August 19, 2008

Re: Issues with water well tests performed for proposed Creekside Memorial Park Cemetery, Tassajara Road, Contra Costa County, California

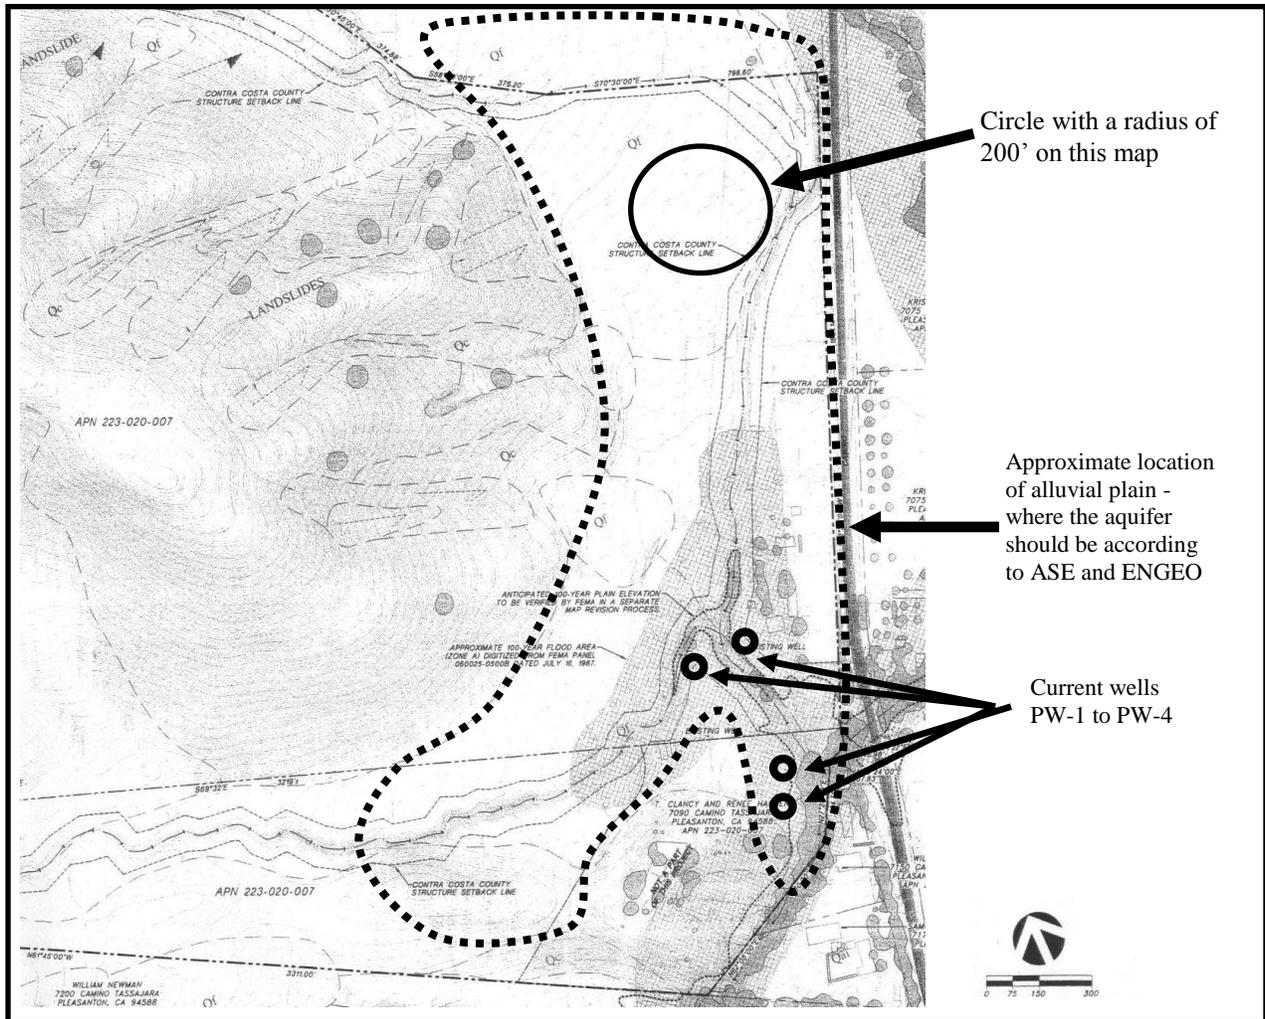
For a test well in this unconfined aquifer, with corrected S and T values (see section 3, point 7) based on Abbott's calculations, the radius of the cone of depression will be 200' after pumping for 720 hours. On the map below, a 200' radius circle is included to give a sense of scale to the cone of depression. Note that even at 200', the well may not encounter aquifer barriers. This example points out the scale and timeframes that are required to get meaningful results. The 720 hour estimate comes from the same source that Abbott uses to calculate his 36 foot radius of depression after 24 hours, namely Driscoll p. 237, equation 9.12 ("intercept of extended straight line at zero drawdown" shows where the cone of depression extends from the pumped well at the top of the aquifer).

additional test wells (and the associated observation wells) should be required. Note that the current four wells are all situated on the lower 25% of the 31 acres as shown in the figure above, and so do not provide sufficient information regarding the extent of the aquifer.

Since we want to establish the size and properties of the entire aquifer, one way to conclusively prove the size of the aquifer would be to install three or four wells and pump them simultaneously until each cone of depression is large, say a 200' radius. If an anomaly shows up in the drawdown graphs we'll know if the aquifer is limited in extent. If the plot stays linear throughout the timeframes where the cones of depression cover a significant portion of the 31 acre aquifer, then the aquifer is more likely to be the size claimed by ASE and ENGEIO.
